# POTENTIAL PLAN CHANGE TO INCREASE RESIDENTIAL CAPACITY AT KINGSTON (Plan Change 25)

Review of draft masterplan

15 October 2008

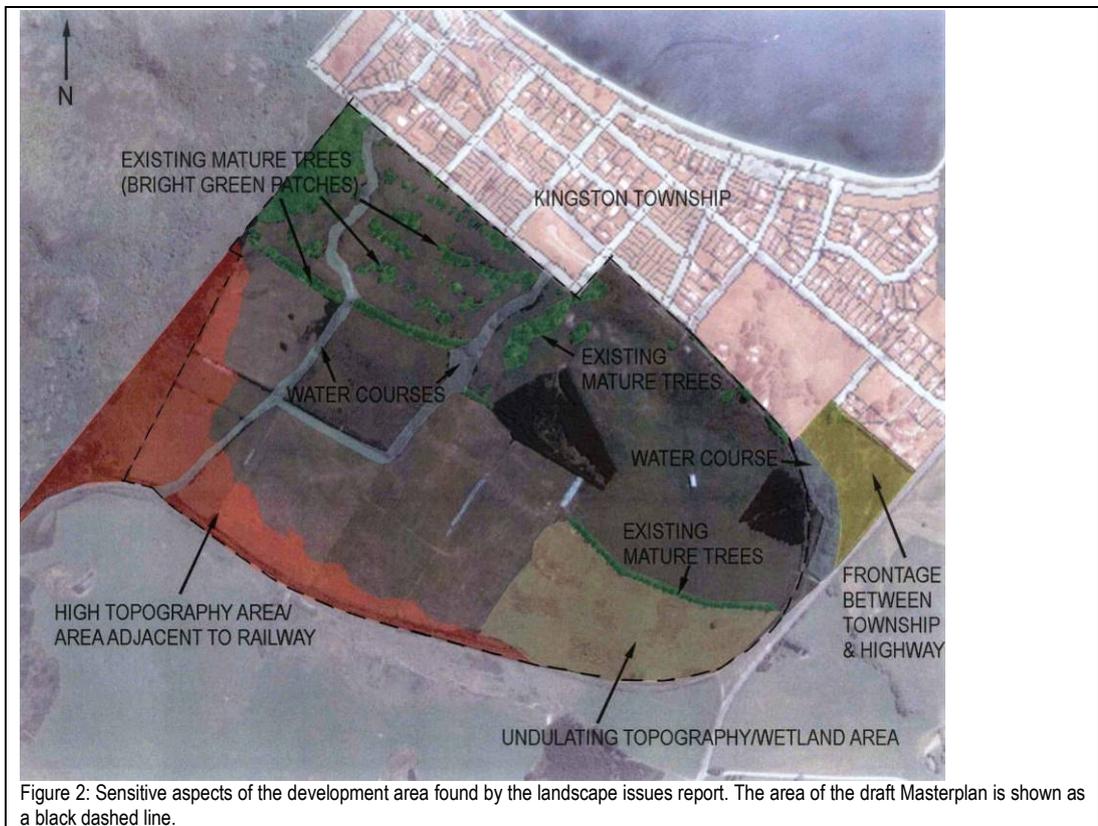
- 3.3 The alignment of the existing watercourses bisecting the development area is shown on the figure above. The western watercourse forks in two as it travels in a northerly direction across the development area and enters the golf course at two points. This watercourse alignment appears to have come about by human modification for agricultural purposes. The draft Masterplan proposes to realign this watercourse such that it drains in a northerly direction as part of a landscaped buffer between the employment activity area and the western part of the residential area (as is shown on Section A of the draft Masterplan). This watercourse will then meet the existing natural alignment that flows through the golf course. The eastern fork of the existing watercourse will be removed but three other north-south running watercourses are provided for within the draft Masterplan area. Again, these are aligned as part of landscaped corridors associated with the roading network.

- 3.4 Given that the existing watercourses that cross the western part of the development area are degraded by stock browsing and have been considerably modified in terms of alignment, we find that the draft Masterplan's treatment of watercourses will not be adverse. The proposed alignment of the new watercourses as components of landscaped corridors will provide for linkages in terms of natural character and ecology and will bring a network of green space amenity into the new suburban fabric.

- 3.5 The existing watercourse at the extreme eastern edge of the development area (shown on Figure 2) is outside of the area that has been considered by the draft Masterplan.

- 3.6 The westernmost (and highest) part of this high topography area has been excluded from the draft Masterplan area (as can be seen on Figure 2. Consequently, no development will occur in this area.

- 3.8 The blocks of residential development labelled as R2, R11 and R17 on the draft Masterplan are also on an area of locally high topography. Again, there are considerable areas of open space adjacent (and to the east) of them that can be effectively used to mitigate potential adverse effects stemming from prominence of buildings. These reserve strips (labelled as LR02, SW03 and, less importantly, LR04) are wide enough to allow good mitigatory planting to be installed. Again, we support the suggestions of the Te Ngahere plan in this regard but suggest emphasising the proposed specimen trees as above.

- 3.12 The existing Township Zone of Kingston fronts State Highway 6 for a stretch of 300 metres. This stretch includes the existing petrol station, café, cemetery and motor camp (which takes up the southern portion of the zone).
- 3.13 As can be seen on Figure 1, the area for potential development that we identified in our Landscape Issues report would potentially extend this frontage in a southerly direction. The draft Masterplan proposes residential development that practically fronts the state highway but is separated from it by the Kingston Flyer track. The draft Masterplan does not address the area between the Kingston Flyer track and the existing Township Zone. This area is identified as “Frontage between Township and Highway” on Figure 2.

- The draft Masterplan area does not address the area between the Kingston Flyer track and the existing Township Zone at the eastern end of the identified development area (as can be seen on Figure 2). We believe that the consideration of this area as part of the overall consideration of the nature of the future highway frontage of an expanded Kingston township is of importance and is an issue that the Council should examine in the future.
- In an overall sense, we find that the proposed draft Masterplan is generally an appropriate response to the site in terms of broad scale landscape planning. In general terms, it will provide a logical and cohesive extension to Kingston.
